Agenda
Village of Arlington Heights
Design Commission
Community Room, 3rd Floor

Arlington Heights Village Hall
33 S. Arlington Heights Road
Arlington Heights, IL 60005
September 26, 2017
6:30 PM

MINUTES OF
THE VILLAGE OF ARLINGTON HEIGHTS
DESIGN COMMISSION MEETING
HELD AT THE ARLINGTON HEIGHTS MUNICIPAL BUILDING
33 S. ARLINGTON HEIGHTS RD.
SEPTEMBER 12, 2017

Approval of revised exterior color packages for the new multi-family townhomes at the Lexington Heritage Subdivision.

3 EAST ELEVATION
A-4 1/4" = 1'-0"

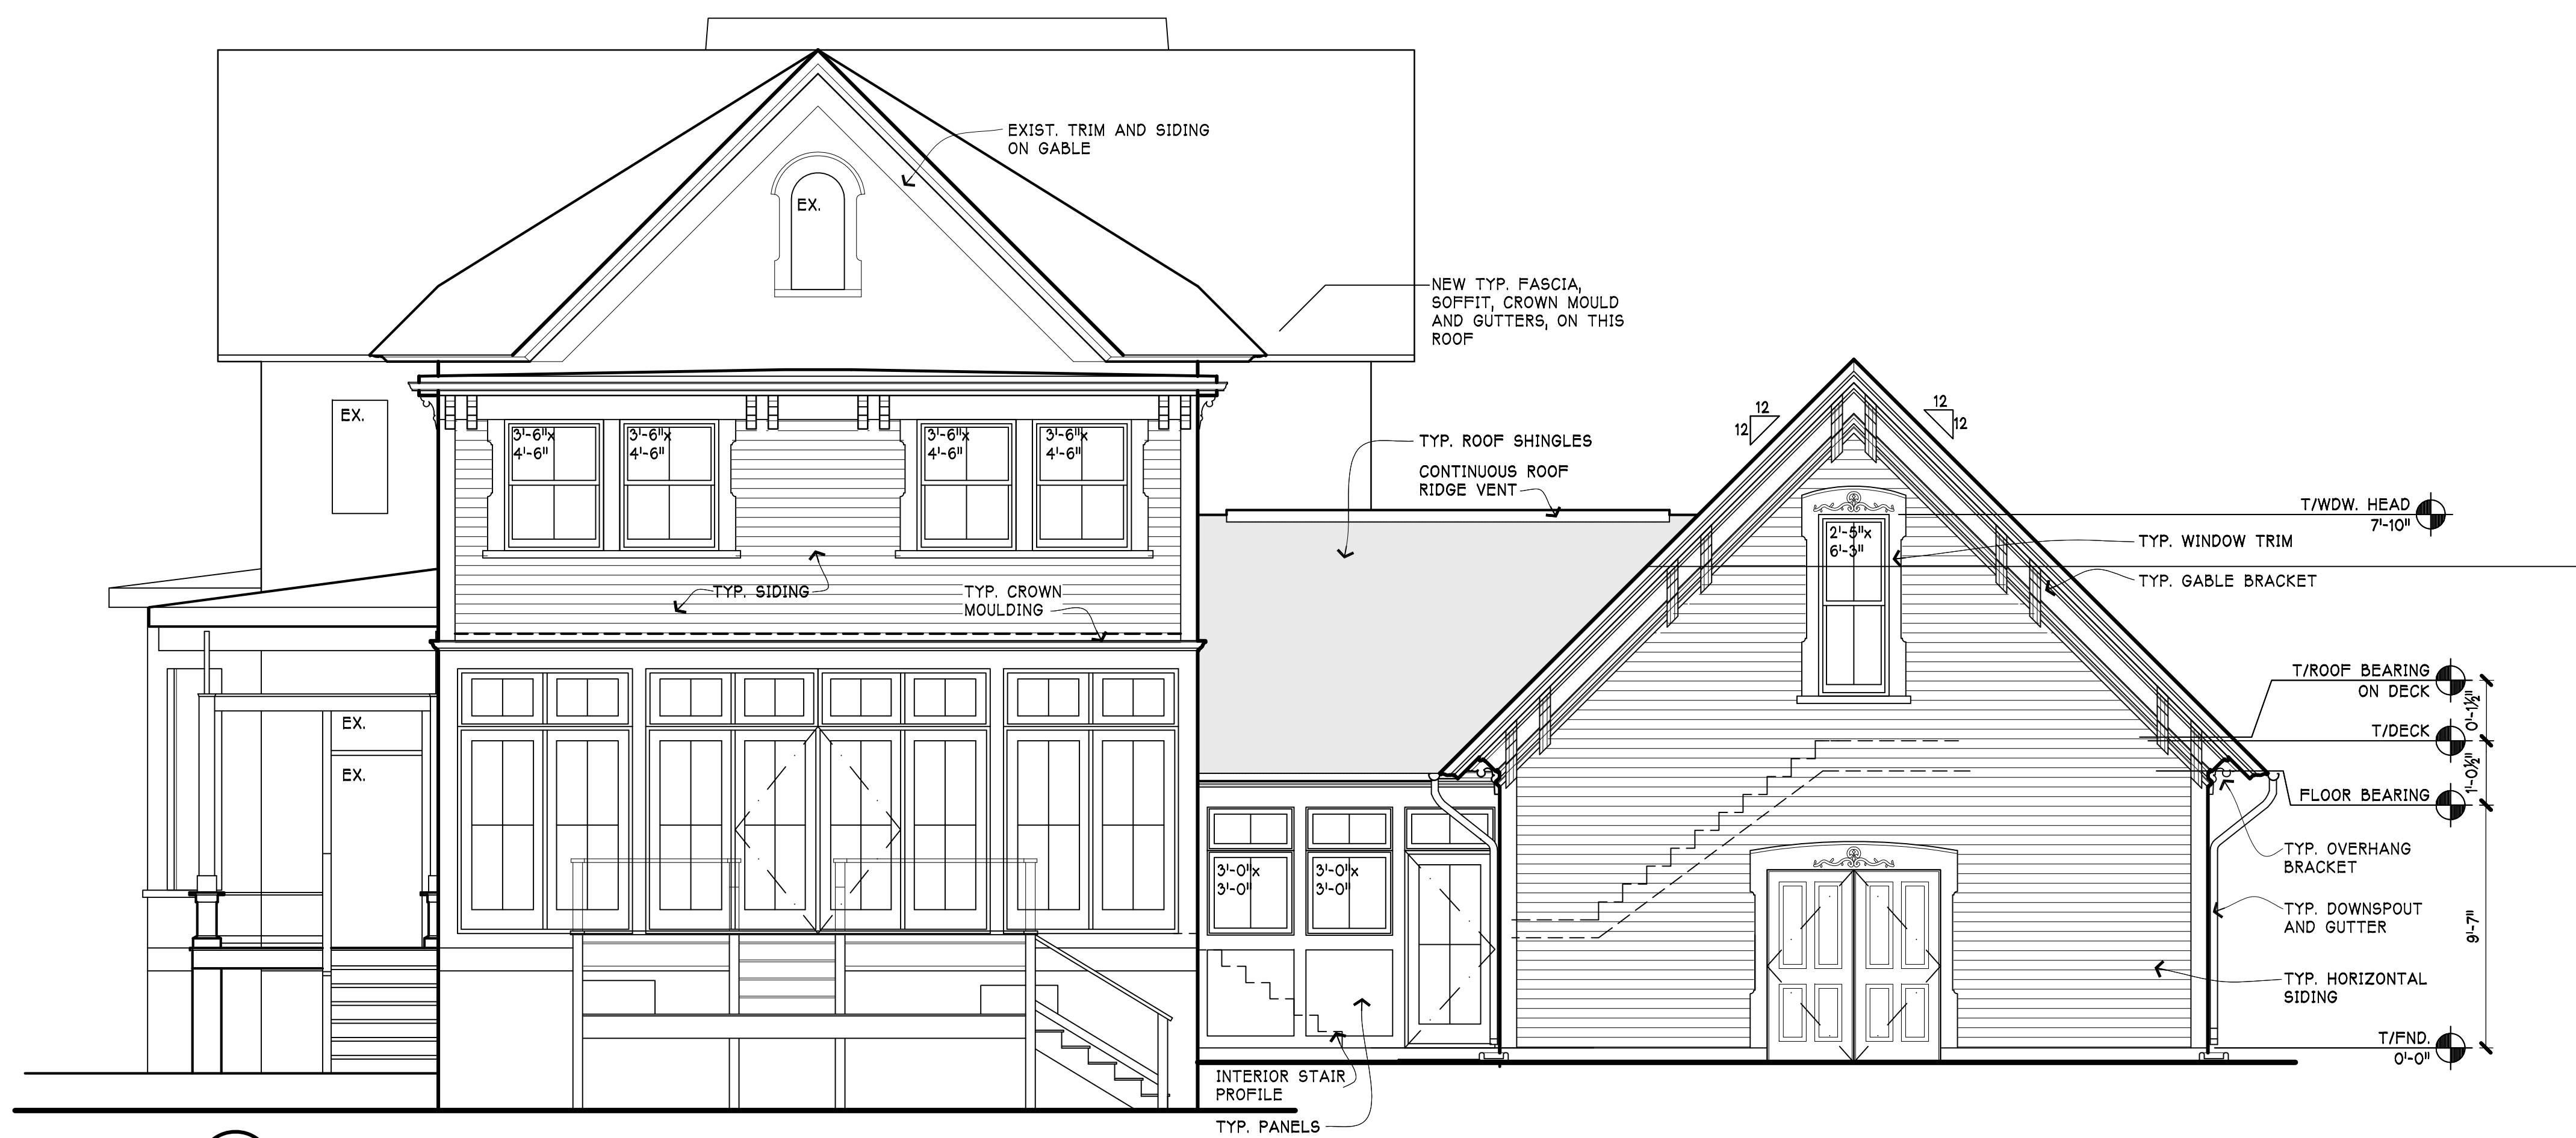
Chair Fitzgerald liked the steepness of the roof, especially the way it relates to the sides of the home, and he liked the dormers being the size and symmetry as proposed. He liked Staff's recommendation to add another window on the garage side of the home, and he especially liked the idea of a window at the bottom of the stairs/landing to fill the space within the porch. He had no issue with the height of the home or the eaves because the home at 618 looks like it has a third-story, and the home at 622 is a 2-1/2-story. He would recommend that the back garage match the door on the front garage, and he liked the colors being proposed.

1. A REQUIREMENT TO ADD A WINDOW ON THE SIDE OF THE GARAGE.
2. A REQUIREMENT TO ADD A WINDOW AT THE STAIRWAY.
3. A RECOMMENDATION TO CREATE A VOLUME SPACE ABOVE THE FRONT ENTRY DOOR.

3 West Elevation
SCALE: 1/8" = 1'-0"

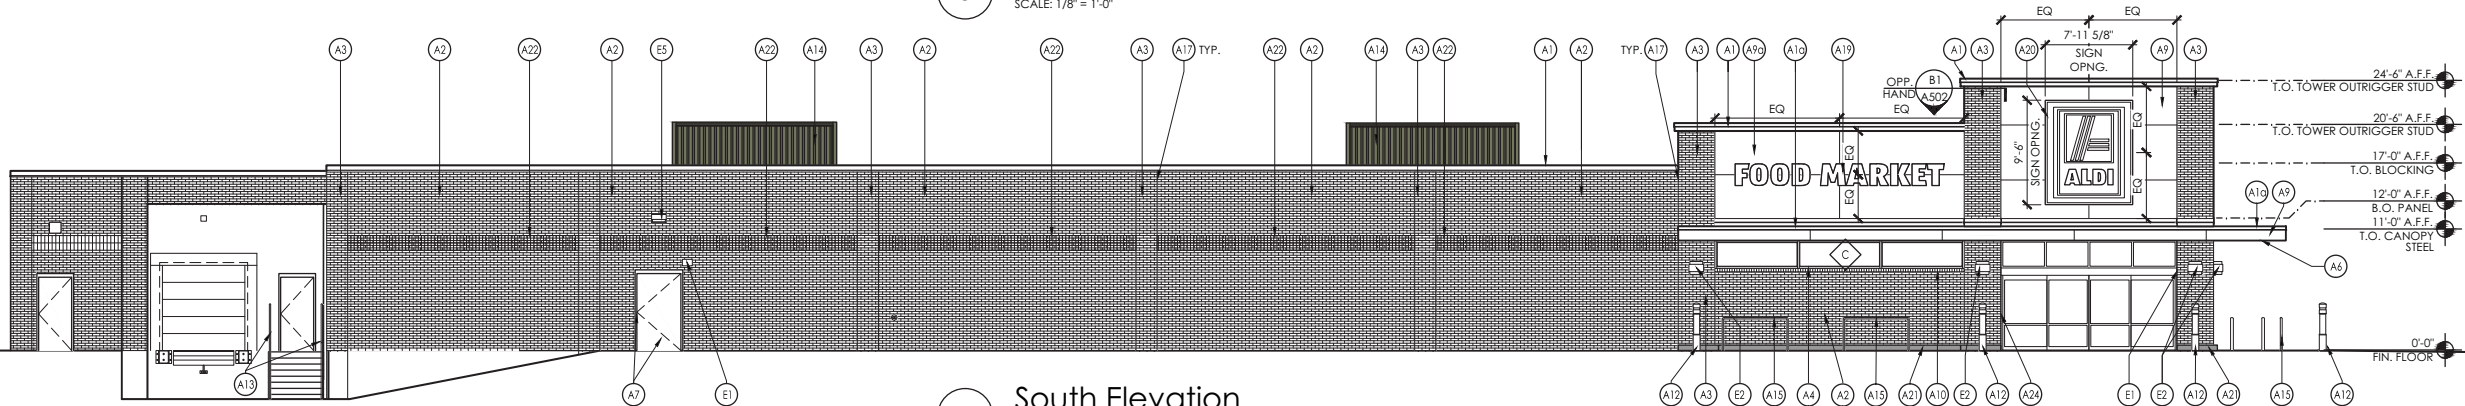
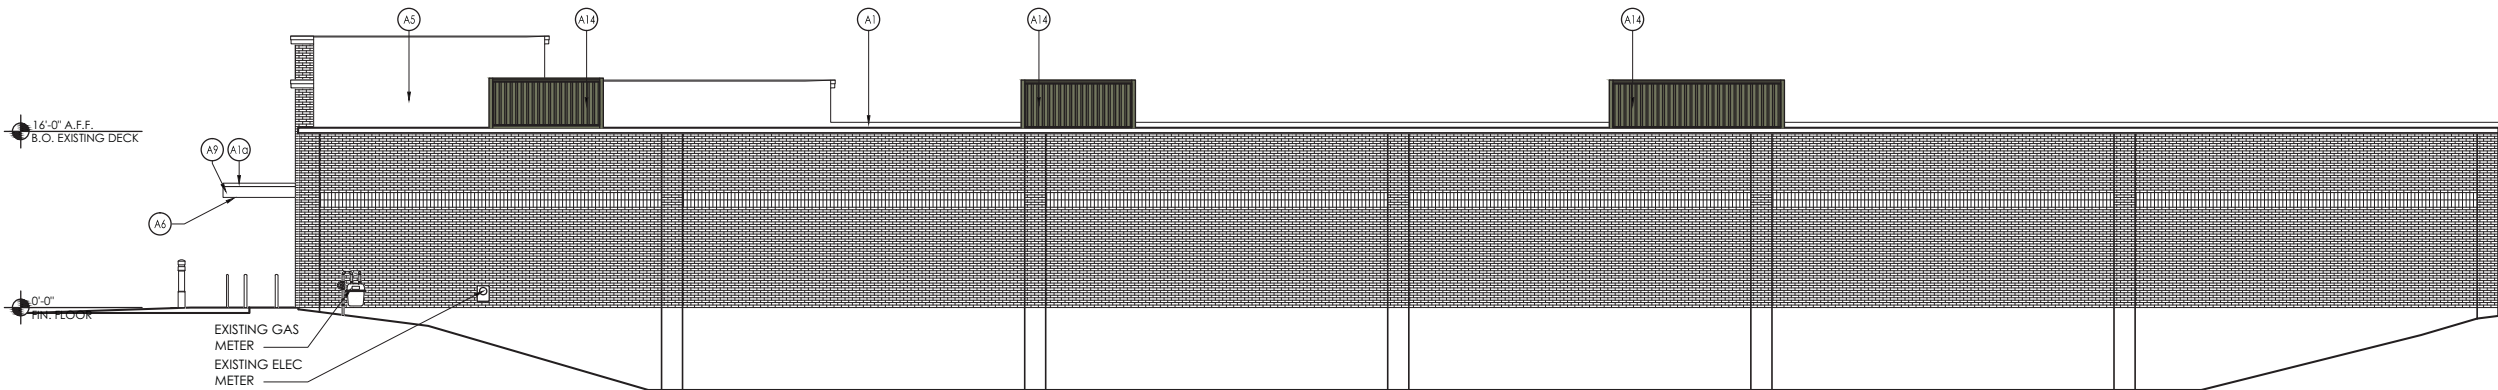
1. It is recommended that transom windows be added at the top of the wall along the south elevation.
2. Provide three additional shade trees in the remaining landscape islands.

3 Proposed East Elevation
SCALE: 1/16" = 1'

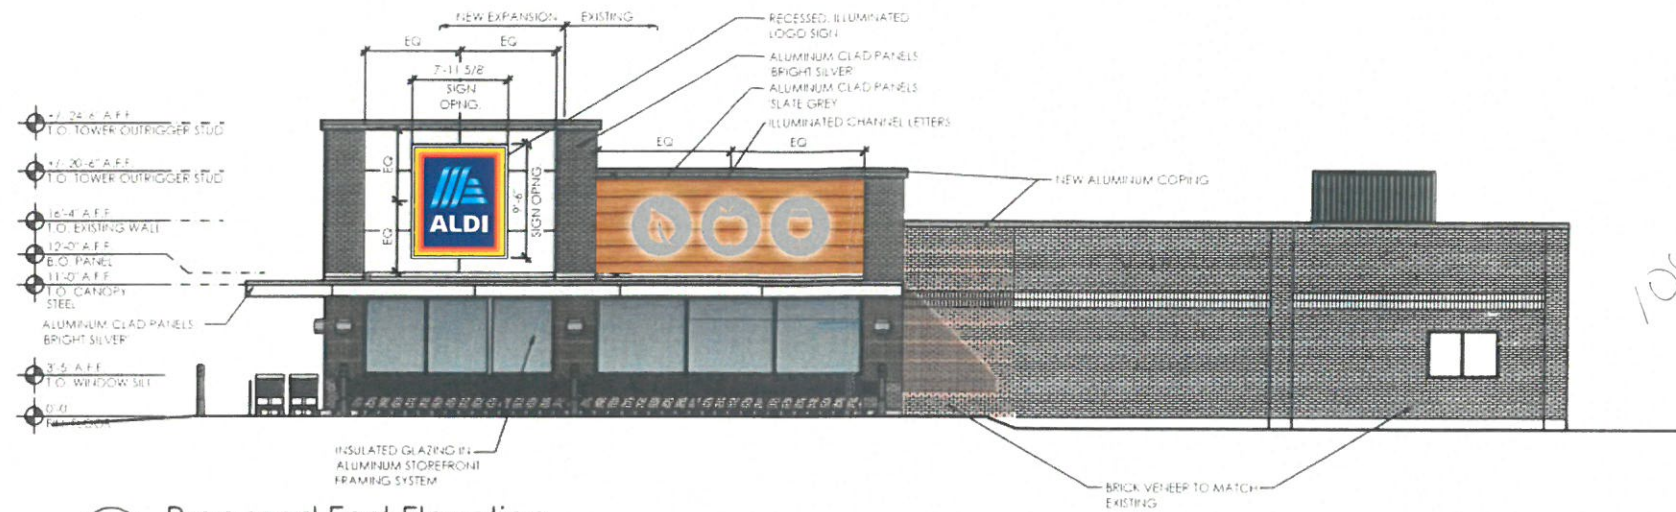
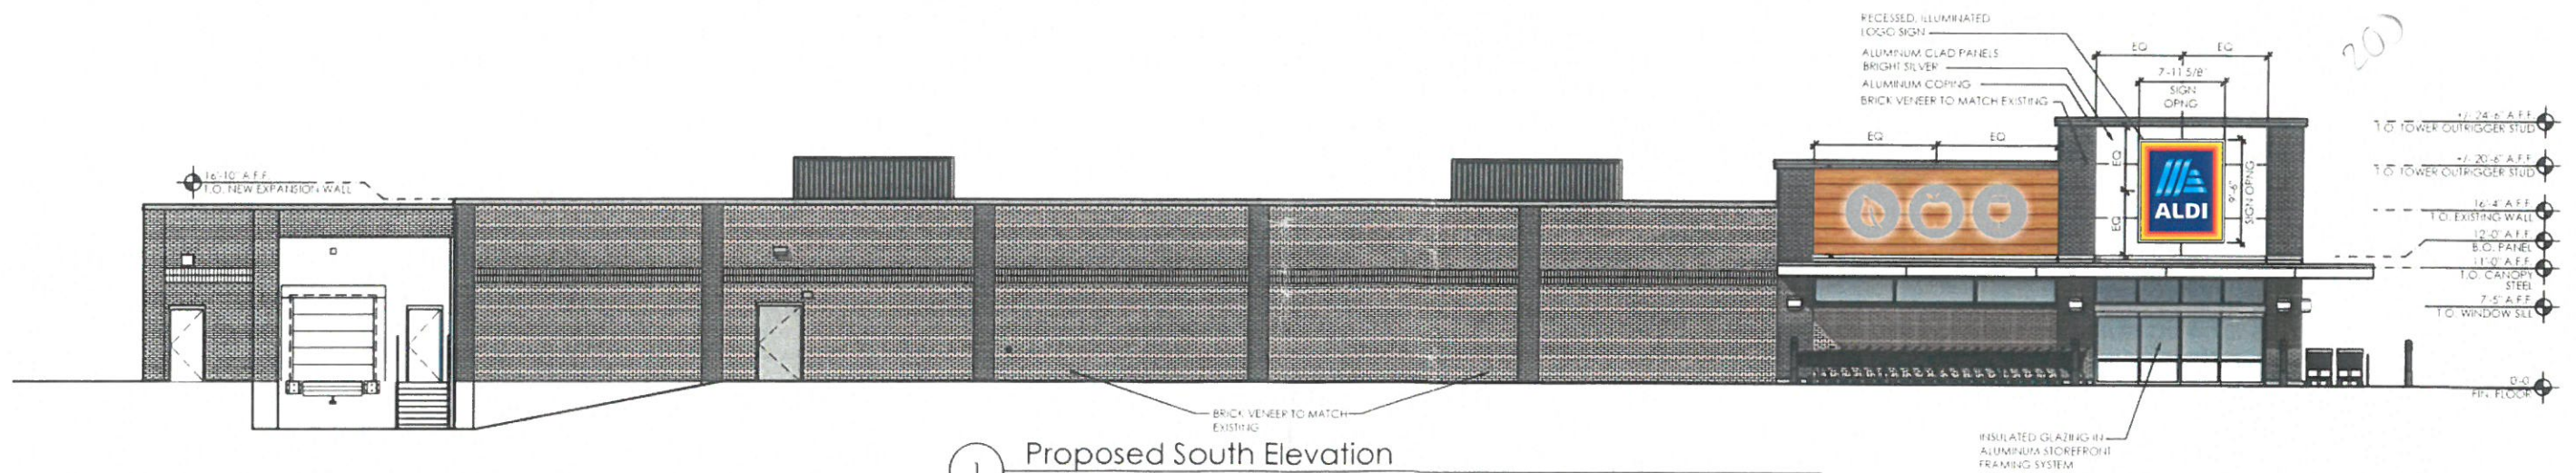
1. Consider reducing the size of the signs.
2. Consider reducing the number of signs.
3. Consider omitting the second wall sign on the east elevation.
4. This review deals with architectural design only and should not be construed to be an approval of, or to have any other impact on, any other zoning and/or land use issues or decisions that stem from zoning, building, signage or any other reviews. In addition to the normal technical review, permit drawings will be reviewed for consistency with the Design Commission and any other Commission or Board approval conditions. It is the architect/homeowner/builder's responsibility to comply with the Design Commission approval and ensure that building permit plans comply with all zoning code, building permit and signage requirements.
